ADDENDUM NO. 5 November 25, 2025

RE: River Corridor Public Sanitary Sewer Extension

Addendum #5 consists of the following:

Sheet Title ELECTRICAL LIGHTING, POWER, & FIRE ALARM FLOOR PLAN

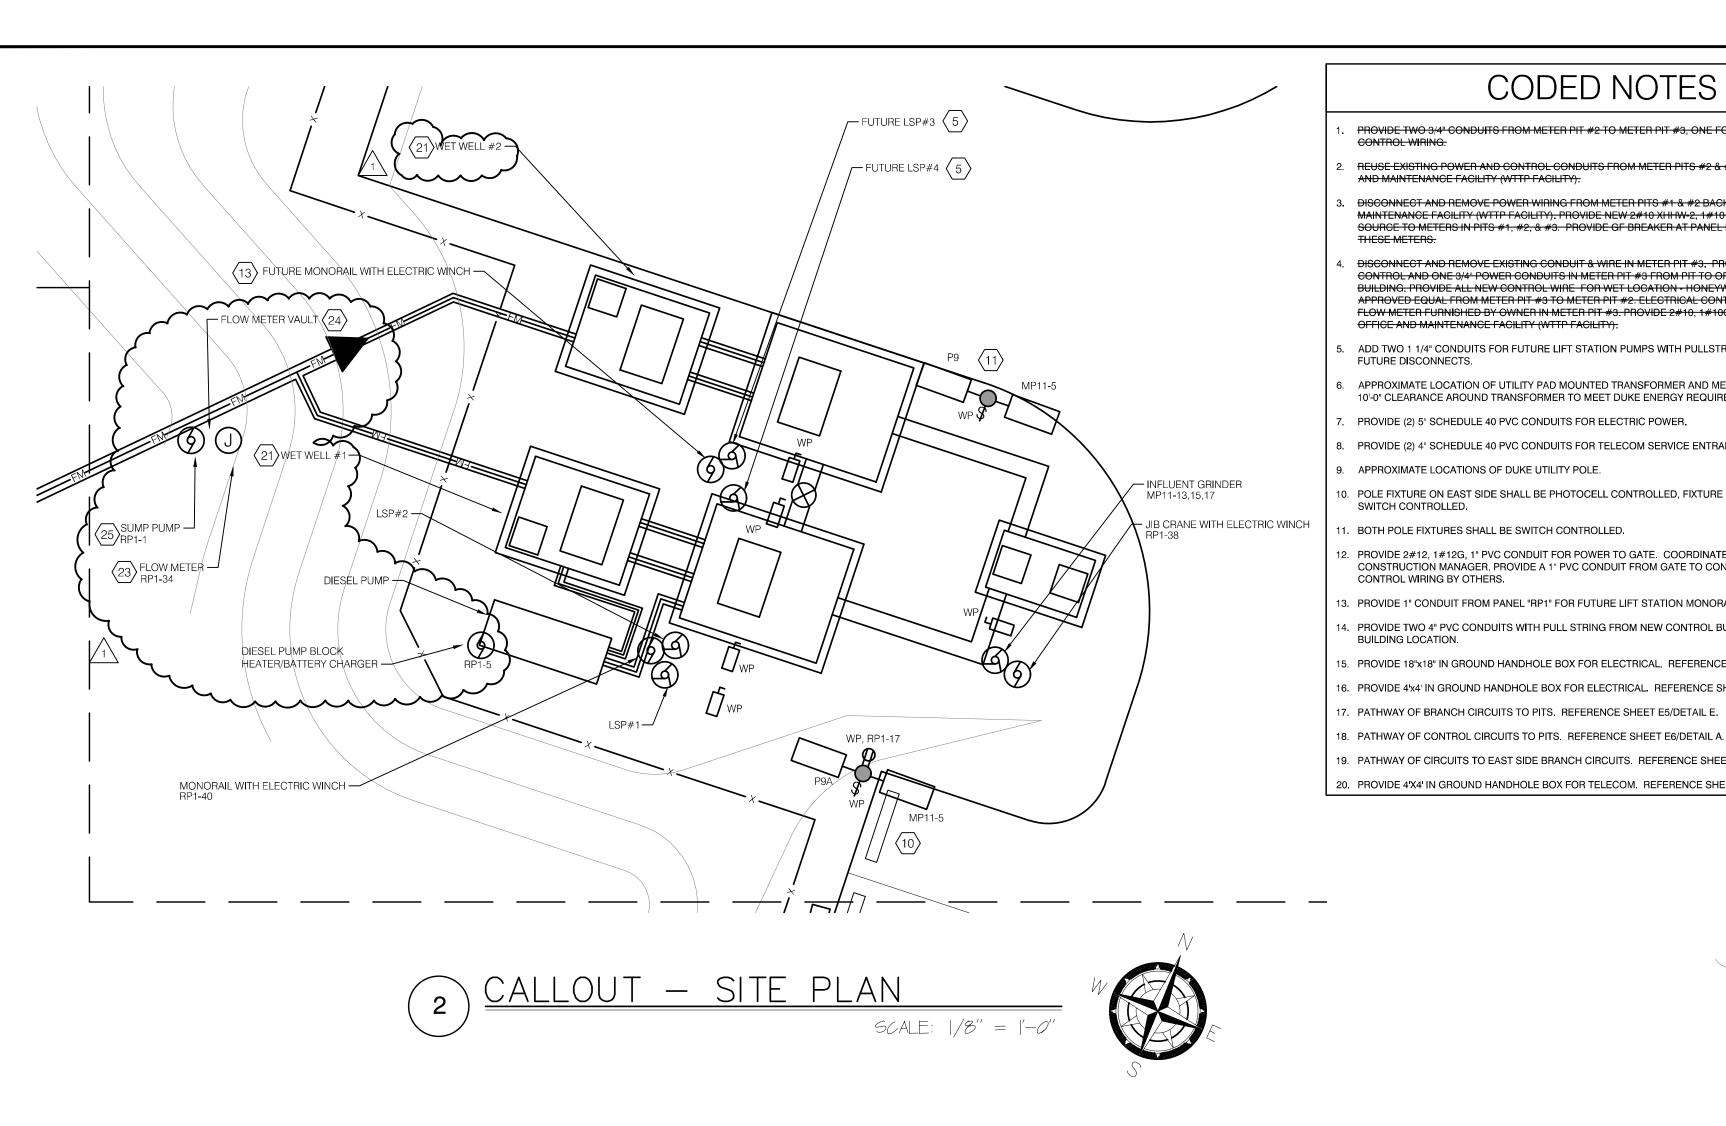
- 1. The following items were missing or unclear in the original bid documents see attached revised electrical drawings E1, E2 & E3.
 - Added conduits from Control Panel to Juction box @ wet wells #1 & #2

- Added circuit to diesel pump for block heater and battery charger
 - Added circuit to jib crane at grinder chamber
 - Added circuit to hoist at wet well

- Added circuit to flow meter
 - Revised circuit to float switch in meter vault
 - *Corrected voltage for sump pump in meter chamber*
 - Added heat trace to circuit for discharge pump

WATERMAIN TRENCH DETAIL - DUCTILE IRON PIPE

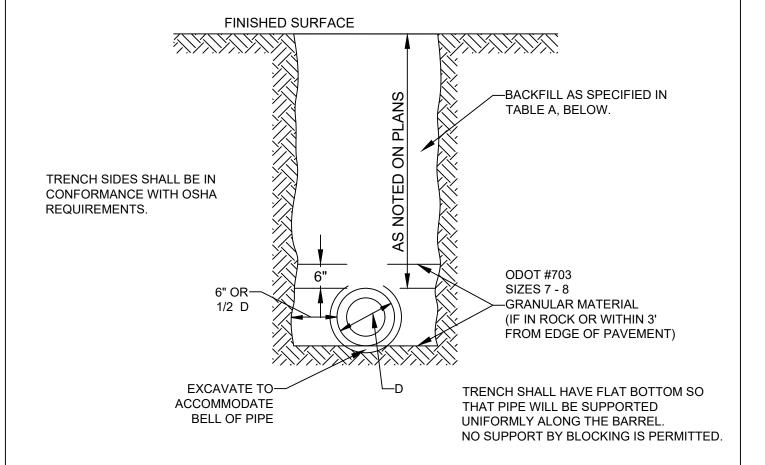
- 2. Warren County Water & Sewer Department updated many of their Trench details. The following revised details are attached W2, W3, W, S7, S8, S9 & S10.
